18 Primrose Lane,
Wokingham
Retrospective Notes

Introduction

West Gable Works

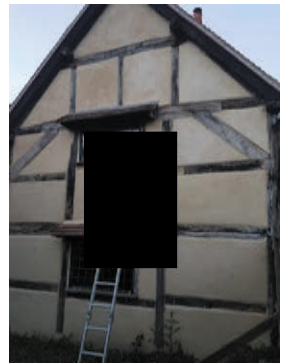
The Conservation officer highlights that the west gable wall has undergone a series of repairs which did not have Listed Building Consent and if undertaken inappropriately could have resulted in further harm to the historic building and its fabric.

The client has confirmed that repair works to the west gable were undertaken in 2017, with Dunne and Co. undertaking these works. The gable was in a poor condition due to being finished with inappropriate masonry paint and a cementious skim, furthermore the rainwater goods in this area were leaking and concentrating water onto some of the timber frame, causing decay. The timber frame had repairs undertaken, retaining as much of the historic fabric possible. The repairs to the timber frame were largely face place repairs and scarf repairs, retaining as much of the historic timber possible.

The infill panels were a combination of brick infill panels, block work panels and lime panels. These were repaired and replaced. The panels were finished with lime render and then lime washed with an ochre lime wash. The lime infill and brick infill panels were retained and repaired, with new lime render put over the panels. The block work infill panels were removed and replaced with lime infill panels, rendered over.

Giles Stephens, the conservation officer at the time of the west gable wall was aware of the works and noted verbally whilst on-site that Listed Building Consent was not required for these works. The email chain above for the windows shows that verbal phone conversations had been held with Giles regarding the gable end wall works, which at the time were coming to an end on-site.

I attach some images below of the condition of the west gable prior to the works being undertaken and over page of the west gable end both internally and externally today.
